Our Ref:230879

8 November 2024

## Objection to Development Application – RA23/1002 (79 – 83 Princess Street & 120 – 122 Queen Street, Berry)

Figure 1: Extract from the Site Plan submitted with the DA, with changes circled in blue (H&E Architects, 2024)

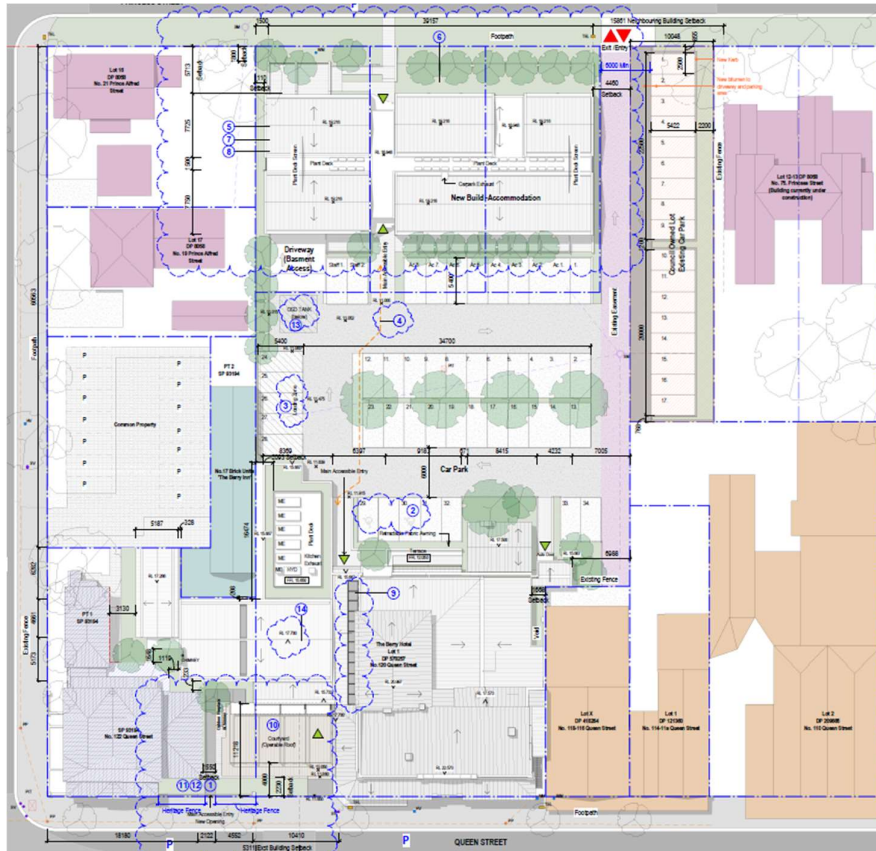
An extract from the current site plan is provided in Figure 1 below to provide an overview of the proposed development.

Figure 4: Extract from the elevation plans, showing the existing elevation (top) and proposed elevation (bottom) (H&E Architects, 2024)

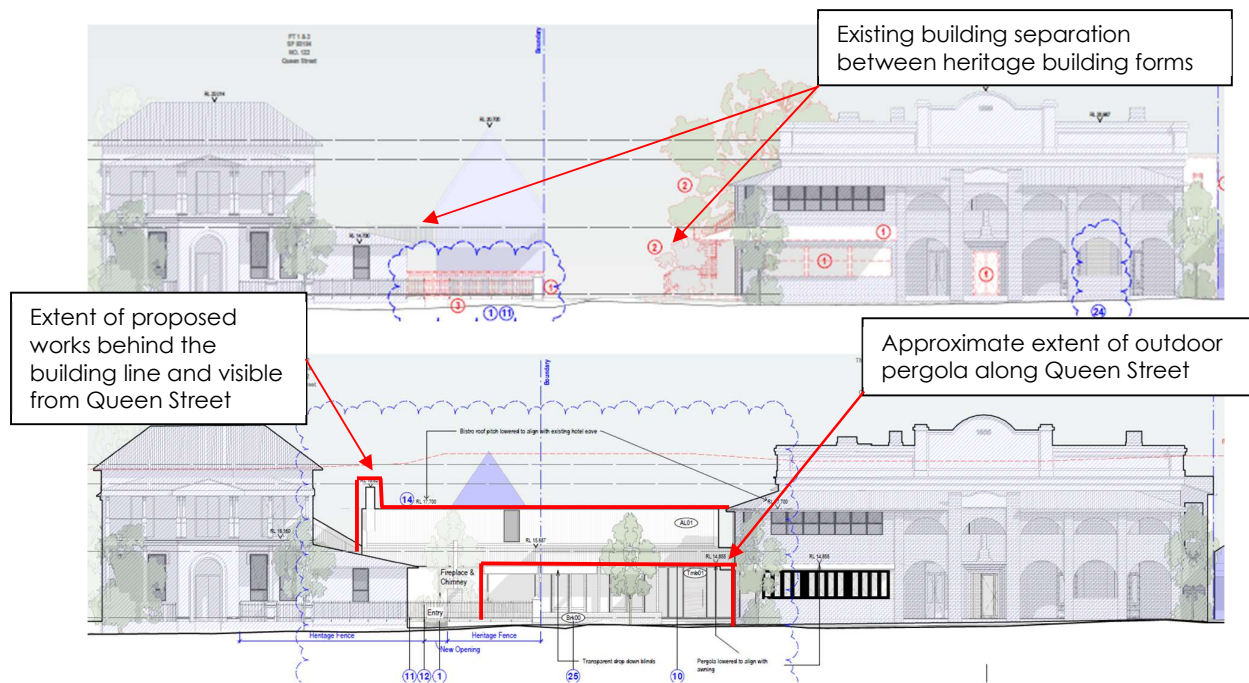
The amendment to the height of the roofline of the bistro and outdoor dining area brings the development more in line with the streetscape (see Figure 4 below), however, the concerns regarding the buffer

between the CBC building and the proposed additions to the Berry Hotel remain. The setback of the outdoor dining pergola has been increased to 2.122m from 1.25m, which does not fully address the separation issues. This narrow separation, in addition to the heritage fence which extends across the CBC building and part of the pergola and the proposed extension of the Berry Hotel extending behind the CBC building, results in the proposed development effectively connecting both structures without sympathetically aligning with either building (see Figures 4 & 5). It is noted that the Berry Hotel and CBC building have long stood independently in the streetscape and this is reflected in the existing generous setbacks of the Berry Museum and former E S and A Bank and garden directly across the road at 135 Queen Street. This building separation between heritage items positively contributes to the streetscape by providing visual interest, highlights the heritage items, provides additional opportunities for landscaping along the street front, and maintains the heritage character of the area. The proposed alterations are therefore inconsistent with the established streetscape of this area, and the development risks overcrowding the heritage items.

The visual disconnect is further emphasized through the use of material and finishes that are inconsistent with the heritage structures. Timber cladding and galvanised steel cladding for the roof is proposed, while the existing Berry Hotel utilises red brick, black trim around windows and walls, and a red roof feature, and the CBC building features tan-coloured rendered walls with a darker yellow/tan roof (see Figure 6 & 7). The design, materials, and colour scheme of the proposed additions are significantly different to the Berry Hotel and CBC building and do not maintain the visual importance of heritage items as required by Section 5.2, Chapter N2 of the SDCP. The design is not considered to be sympathetic to the heritage and aesthetic values of the area and has not adequately considered the impact of the proposal on the heritage significance of the item. As such, the proposal is not consistent with the relevant heritage requirements with the SDCP or Clause 5.10 of the SLEP.

Figure 8: Extract from the Princess Street elevations, with the existing elevations (top) and proposed elevations

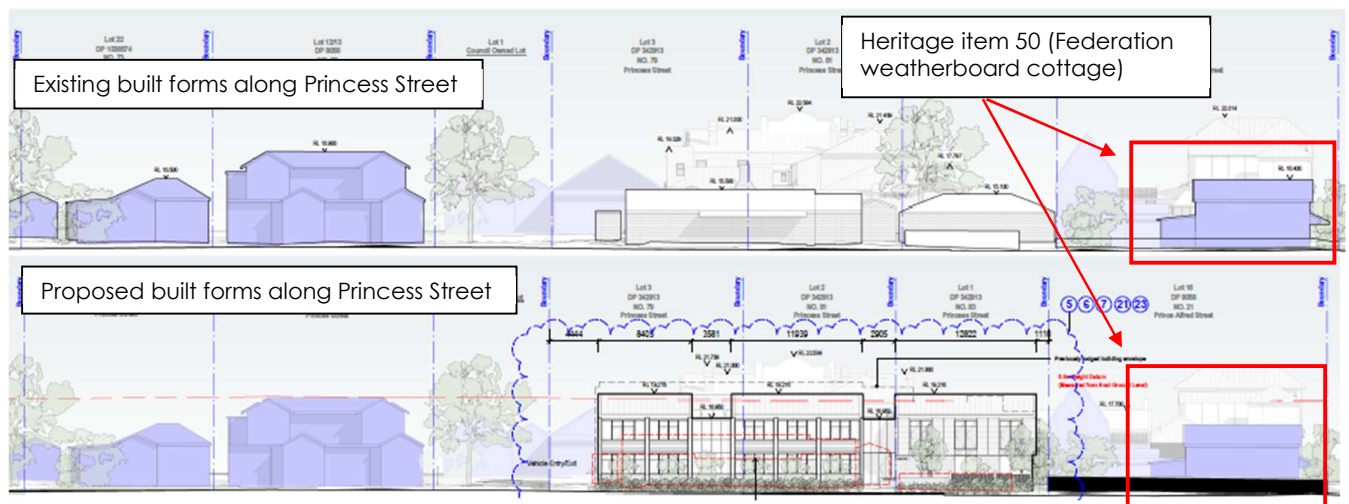
The proposed accommodation building will present to the street as a medium density development, akin to a row of town houses, due to the protruding internal walls and privacy screening that visually divides the building (see Figure 8 & 9 below). This design is significantly different to the heritage and non-heritage development surrounding in the area, noting that the area is comprised of predominantly low-density forms. The surrounding area, particularly Princess Street, does not accommodate terraced housing or other similar built forms which leads to the proposal being visually distinct from surrounding developments. Additionally, the vertical features of the proposal, such as the protruding walls and vertical privacy screens, contribute to the medium-density aesthetic and modern design of the proposal. Many two-storey heritage items in the area use horizontal design features, such as wrap-around verandas, which is also reflected in many non-heritage developments in the area though verandas, increased setbacks for upper floors, and/or material changes between storeys. These design attributes have not been considered for the proposed accommodation building, and as such the design provides no connection to the surrounding heritage character of the area. Due to the scale and location of this proposal along Princess Street, the proposal would visually dominate the streetscape and become a main focal point, as seen in Figure 8 below. This would overwhelm the heritage items in the immediate area, including the heritage item on the adjoining site to the east, and is therefore not considered to be sympathetic to the heritage character of the area.

This disconnect between the proposed accommodation building and surrounding heritage character of the area is further exacerbated by the proposed materials and finishes, and the colour scheme. Most heritage items in the area utilise a natural red brick or painted weatherboard along the external façade, with the colour scheme often incorporating the natural red colour of the brick or yellow or blue tones. However, the proposed development seeks to use natural timber cladding, painted weatherboard, and painted brick, with the colour scheme being natural timber, and white/grey (see Figure 10 below). While elements of this design, such as the use of painted weatherboards, provides some connection to surrounding heritage items, the colour scheme and material choices as a whole make the proposal appear as distinctly modern with no connection to surrounding heritage items or the heritage character of the area.
